POLICE STATION – SAFWAN IHP  
404  
BASRAH, IRAQ

PROJECT NUMBER SIGIR-PA-06-051  
JULY 24, 2006

SUBJECT: Report on Project Assessment of the Safwan Iraqi Highway Patrol  
Construction, Safwan, Iraq (Report Number SIGIR-PA-06-051)

## **Police Station – Safwan IHP 404, Basrah, Iraq**

**Site Photo 17: Concrete pad for generator unit**

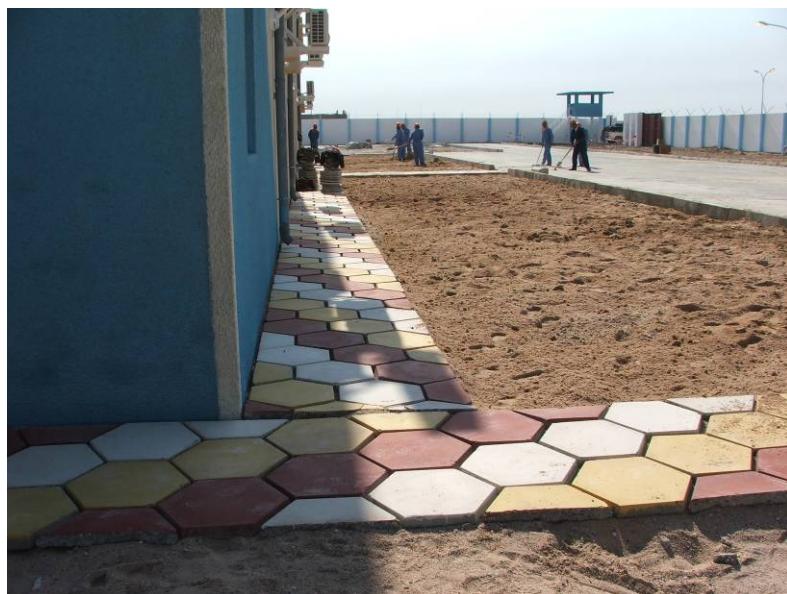
The contract required a complete electrical power generation plant (as needed) which includes an electrical distribution system and diesel engine generators. The approved design required a 350 Kilovolt-Amp (kVA) diesel generator unit with controls to be mounted on a reinforced concrete pad with protective shade covering. The submitted manufacturer's specification included a skid mounted Perkins 400 kVA generator package. At the time of the assessment the concrete pad was constructed, although the generator had not been delivered to the site. The framework for the protective shade covering was under construction. Site Photo 17 shows the concrete pad for mounting the generator unit.
